TO: ALL HOLDERS OF STANDARD DETAILS BOOK, VOLUME 3

SUBJECT: ERRATA TO ADDENDUM 1 OF THE 1999 STANDARD DETAILS BOOK,
VOLUME 3

AASHTO TYPE III
 45" PRECAST CONC. BEAM
 BRD-III 45X16

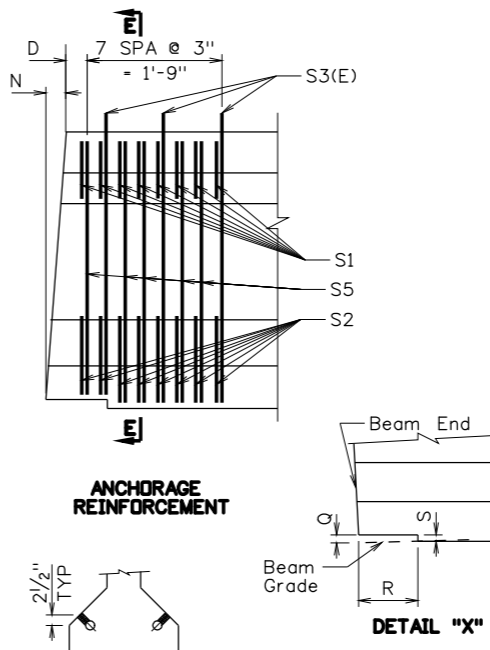
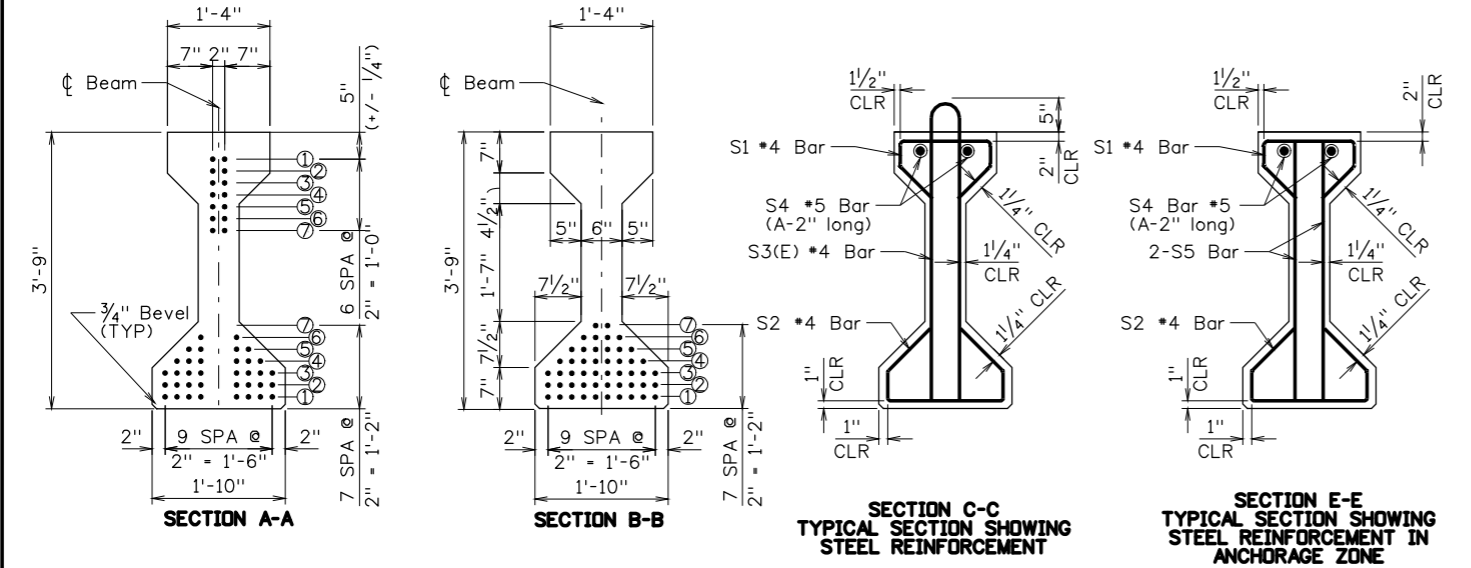
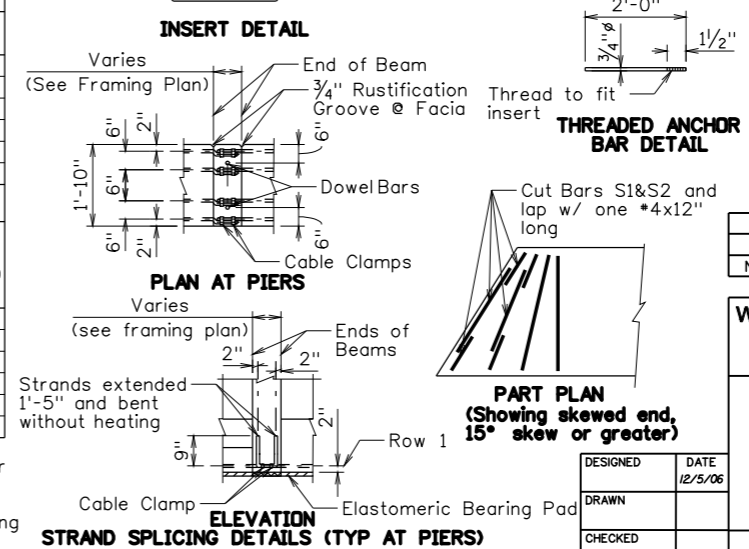
Attached for your use is an errata sheet that is to be changed in the Engineering Division's newly published Addendum 1 to the 1999 Standard Details Book, Volume 3. This page will replace a duplicate copy of the sheet titled "BRD-IV 54X20".

Remove and destroy the first copy of BRD-IV 54X20 and replace it with the errata sheet title "BRD-III 45X16".
